Clinch River Nuclear Site
NRC Docket No. 52-047

Subject: Submittal of Supplemental Information Related to Emergency Planning
Correspondence Between Tennessee Emergency Management Agency and
Tennessee Valley Authority in Support of Early Site Permit Application for
Clinch River Nuclear Site

TVA-TEMA Correspondence Letters

Description of the Clinch River 2-Mile EPZ

- Clinch River Site
- EPZ Boundary
- 2-mile radius
- Waterways
- Tennessee State Parks
- Railroad
- Limited Access
- Highway
- Major Road
- Local Road

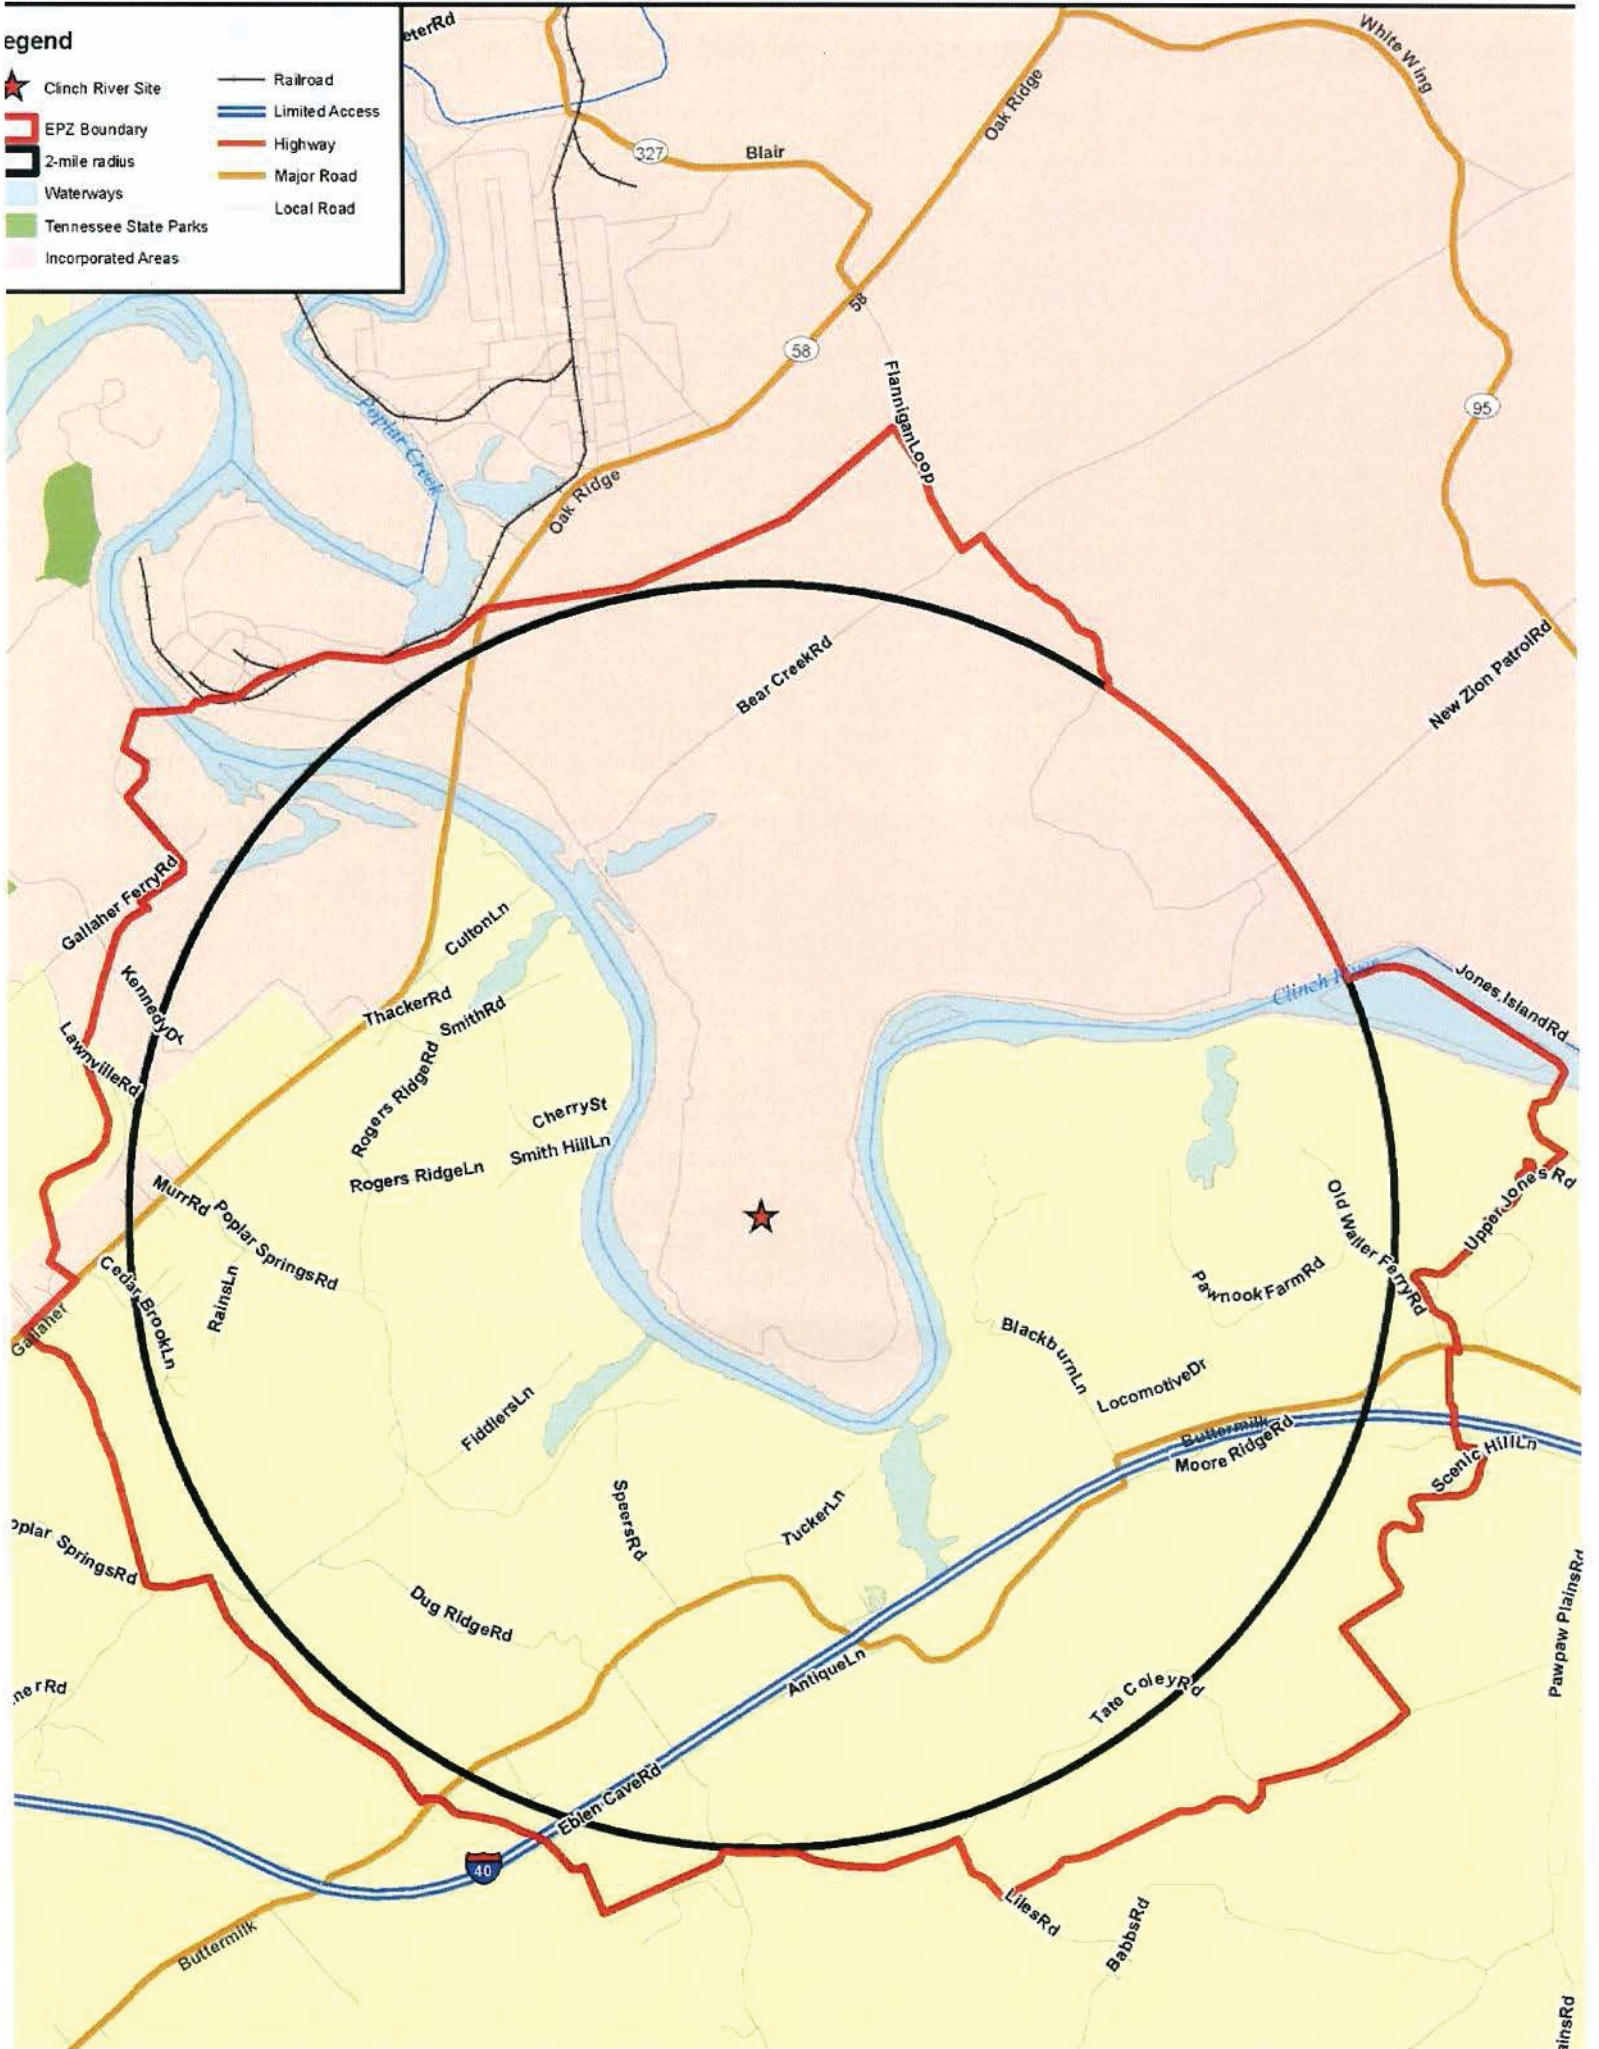
Specifically, information regarding the source term of the fuel for the SMRs needs to be identified. Additionally, specific information on the SMR's design and passive safety systems must be made available for review before any EPZ recommendation can be supported. We also concur with Roane County that an Emergency Alert System which is compatible with the system used by the Department of Energy is needed. Until these and other technical questions have been addressed, sufficient information is simply not available to make a determination regarding the appropriate EPZ for this proposed project.

TEMA will remain a strong supporter of this project and will gladly voice this support to the NRC. However, until more complete technical information is available and the Draft Evacuation Time Estimate study is reviewed, we are not in a position to comment one way or another regarding the appropriate EPZ for the project.
